Contract #: 04-0120F4
 Cty: SF/ALA Rte: 80 PM: 13.2/13.9
 File #: 69.25B

QUALITY ASSURANCE -- NON-CONFORMANCE REPORT

Report No: NCR-000670

Reference Description: Partial Backing Bar Removal, South Tower Lift 4, A/E Corner Backfill Plate

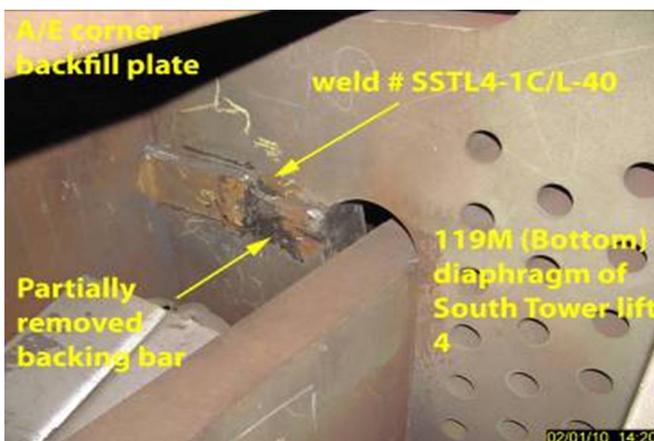
During random verification Ultrasonic Testing (UT) of A/E corner backfill plate of South Tower Lift 4, Caltrans Quality Assurance (QA) observed the following issues:

- Backing has been partially removed at two weld locations, SSSL4-1C/L-40 at 119M (bottom) diaphragm and SSSL4-1F/L-100 at 123M (top) diaphragm.
- These welds join the backfill plates and double diaphragm plates of South Tower lift 4.
- The members are located in Tower Bay 10.

AWS D1.5 (2002) Section 3.13.2: "Groove welds made with the use of steel backing shall have the weld metal thoroughly fused with the backing. Steel backing shall be continuous for the full length of each weld made with

ZPMC has removed the backing bar entirely and is providing NDT of the weld to show that it is acceptable. Discussions between the ABFJV QCM and ZPMC prompted ZPMC to remove the remaining backing bar. ZPMC requests closure of this NCR.

The proposed resolution is acceptable. The Department concurs that Non-conformance ZPMC-0638 is closed.

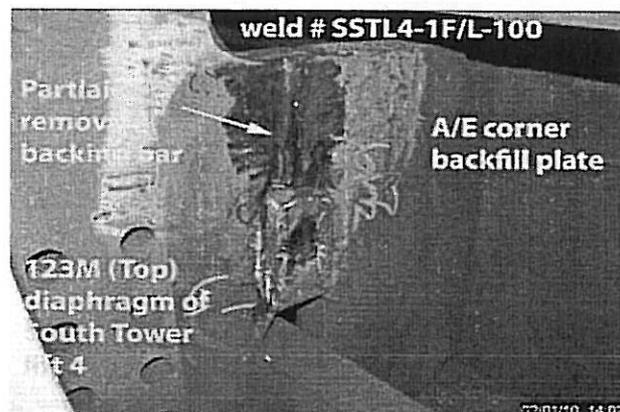
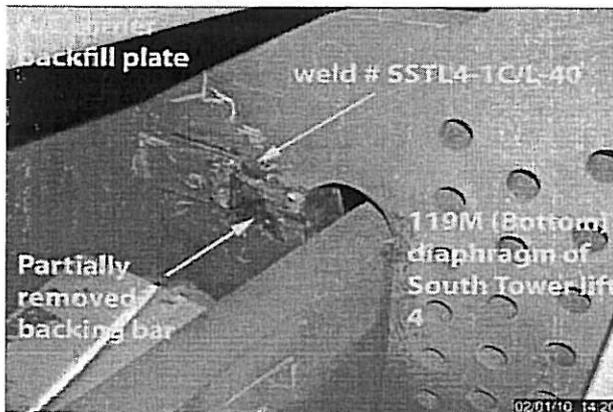
During random verification Ultrasonic Testing (UT) of A/E corner backfill plate of South Tower Lift 4, Caltrans Quality Assurance (QA) observed the following issues:

- Backing has been partially removed at two weld locations, SSSL4-1C/L-40 at 119M (bottom) diaphragm and SSSL4-1F/L-100 at 123M (top) diaphragm.
- These welds join the backfill plates and double diaphragm plates of South Tower lift 4.
- The members are located in Tower Bay 10.

AWS D1.5 (2002) Section 3.13.2: "Groove welds made with the use of steel backing shall have the weld metal thoroughly fused with the backing. Steel backing shall be continuous for the full length of each weld made with

Remove the remaining backing bars, provide NDT to show that the welds are acceptable.

Backing bars were removed and UT report T787-UT-2658 was provided showing the welds are acceptable.
